Subject: Duke Energy Carolinas, LLC
Oconee Nuclear Station, Units 1, 2, and 3
Docket Numbers 50-269, 50-270, and 50-287,
Renewed Operating Licenses DPR-38, DPR-47, and DPR-55
Tornado and High Energy Line Break (HELB) Mitigation License Amendment
Requests (LARs) - Responses to Request for Additional Information

Enclosure 1 contains Duke Energy's responses to the RAI dated November 4, 2011. Additional time was necessary to provide supplemental information to appropriately address the following RAIs. The listed information will be provided by the indicated schedule.

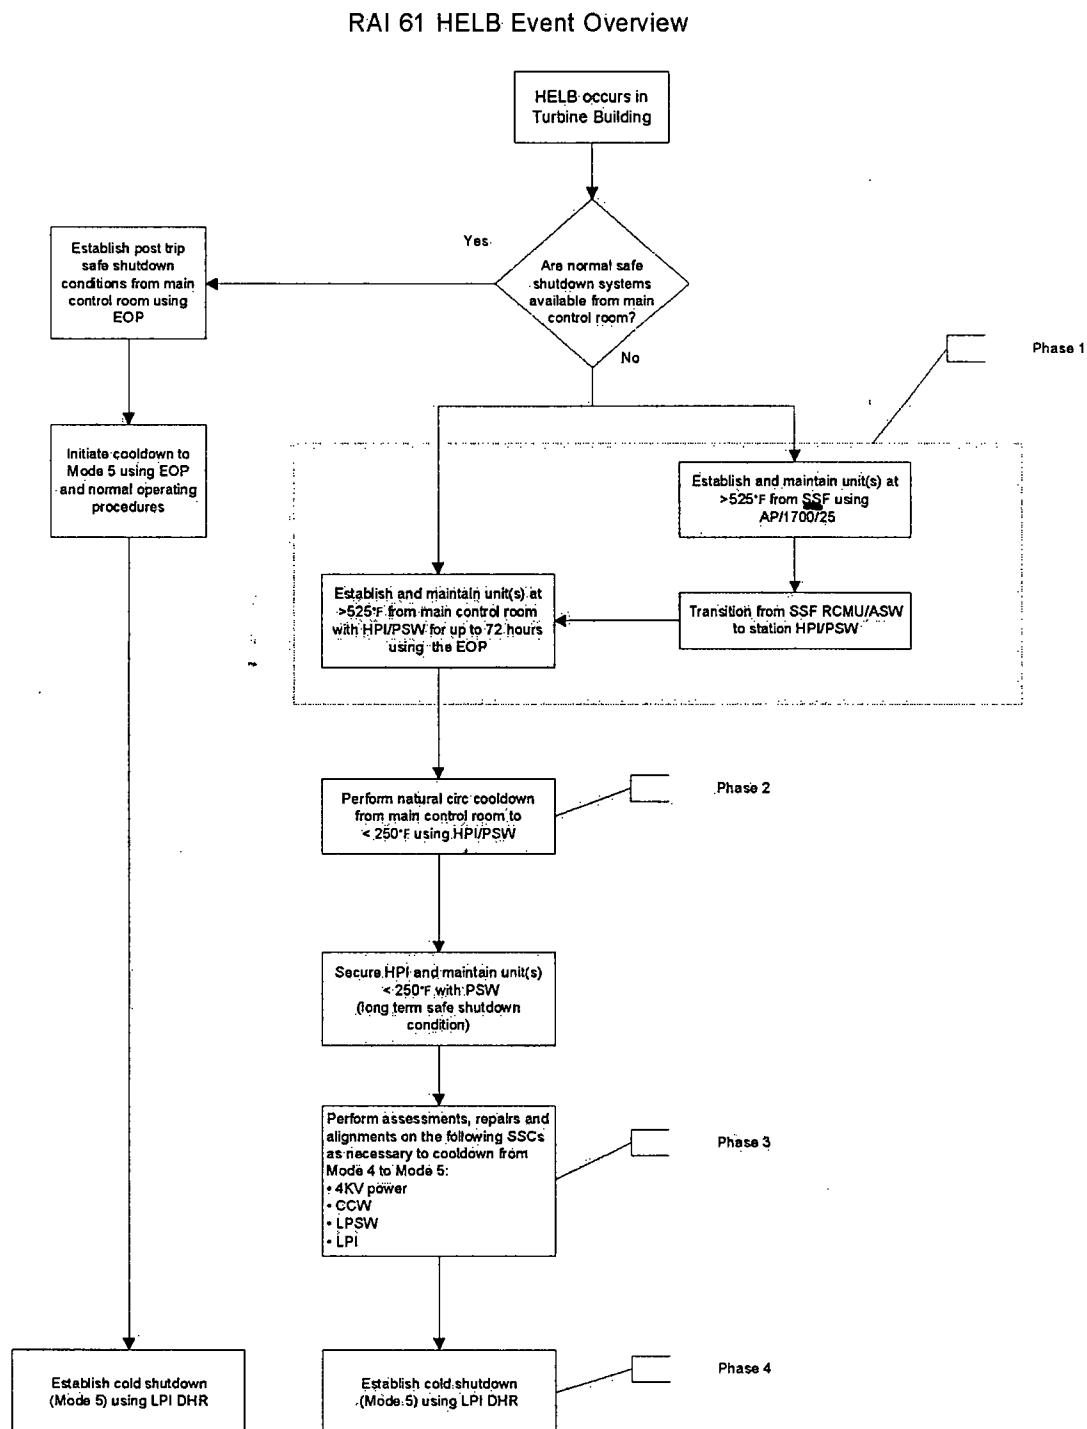
Provide a complete event sequence following a tornado and/or an HELB. In your response, provide a summary of the sequence of actions required for achieving each phase of the mitigating strategies showing how MODES of operation 3, 4, and 5 as defined in Table 1.1-1 of your Technical Specifications (TSs) will be achieved. Identify all equipment that will be available following the events to mitigate a tornado and/or an HELB. Identify all required operator actions, and when each operator action has to be completed. Identify all required repairs, and when they must be completed. For any necessary repairs provide the actions required, manpower required, and all equipment and parts that are necessary to complete the repairs. Demonstrate that the sequence of events would not result in unacceptable radiological consequences. Identify and justify the selected acceptance criteria (fission product barriers are maintained, and the spent fuel remains within the licensing basis). Provide a detailed description of the analyses performed to support the conclusions.

Mitigation of these postulated HELBs is divided into four distinct phases. Phase 1 is reactor shutdown and the stabilization of the affected unit(s) in Mode 3 with Reactor Coolant (RC) average temperature \geq 525°F. Phase 2 is the plant cooldown from Mode 3 to Mode 4 ($< 250^{\circ}\text{F}$). Phase 3 is the assessment and repair of structures, systems, and components (SSCs) required to transition the unit from Mode 4 ($< 250^{\circ}\text{F}$) to Mode 5 ($< 200^{\circ}\text{F}$). Phase 4 is the plant cooldown to Mode 5 ($< 200^{\circ}\text{F}$). The following response is based on approval of the revised mitigation strategy and subsequent completion of committed modifications, and revisions to the mitigation and recovery procedures.

Refer to enclosed flowchart for overview of mitigation strategy addressed in this response.

Sketch RAI-87

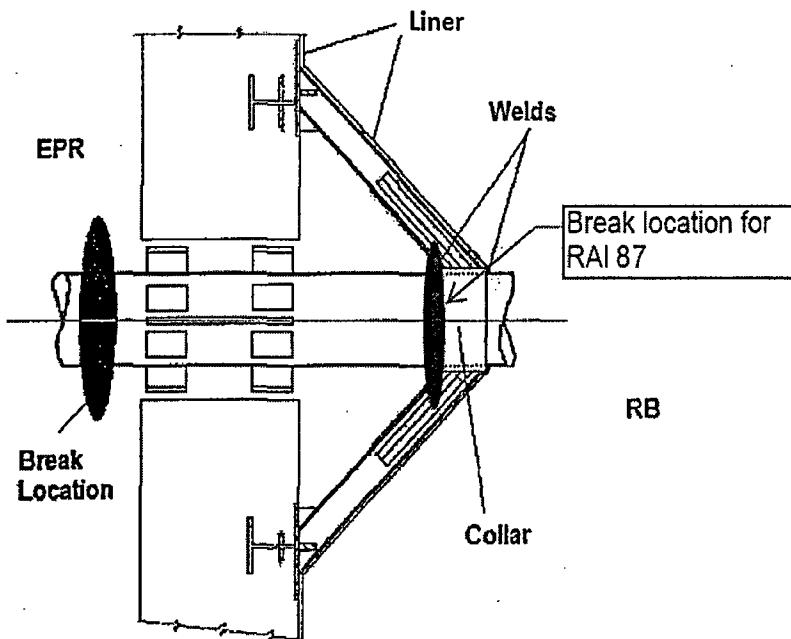
It is not clear in the licensee's October 23, 2009, response to RAI 10 how the containment liner was evaluated for jet impingement and pressurization loads resulting from the break depicted in the RAI response.

Please address whether the potential attenuation of loading, due to the presence of the reactor building wall between the break and the liner, was credited for in the evaluation.

Discuss a postulated terminal end break outside the containment boundary on the main steam anchor (see sketch below), and evaluate the effect that this break will have on the containment integrity or provide a technical justification why such a break is not required to be postulated.

Sketch RAI-9(a)

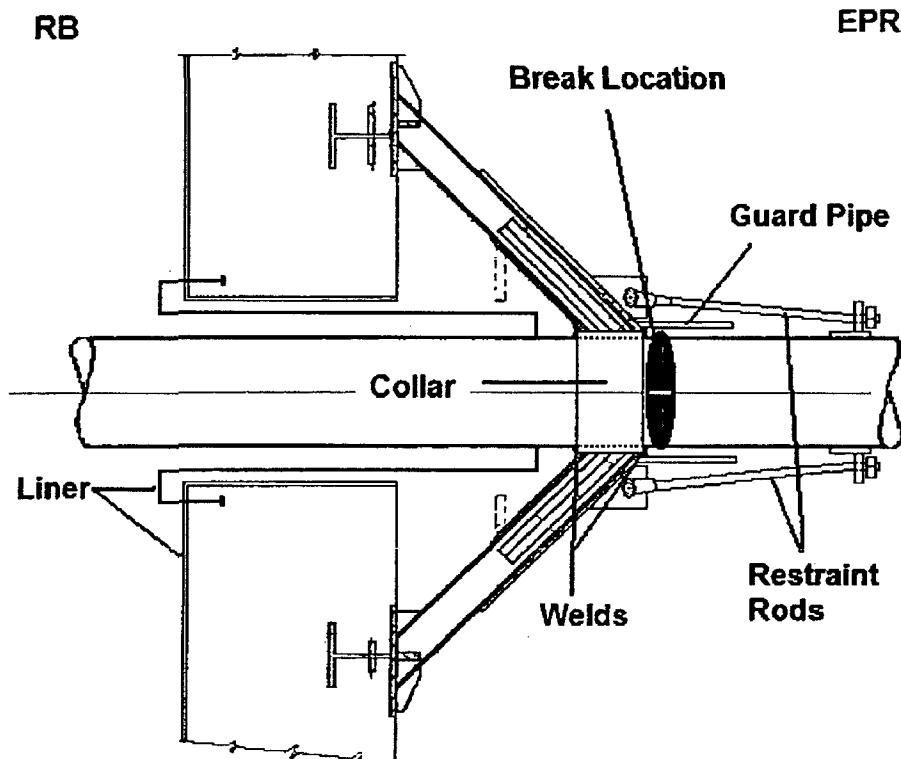
- a) Provide an acceptable justification for not postulating breaks on both sides of this anchor.
- b) Please describe the consequences of the terminal end failure of the feedwater system within the auxiliary building that could occur on the reactor building side of the rupture restraint. Provide an analysis supporting this description.
- c) List any other inline anchors where breaks have been postulated on one side only.

The postulated break location at the MFDW rupture restraint remains unchanged from the original MDS Report No. OS-73.2. The Atomic Energy Commission (AEC) previously accepted the report with the break location at the MFDW rupture restraint as shown on Figure 2.1-4.c of the report. A detailed sketch, showing the rupture restraint and the original postulated break location follows.
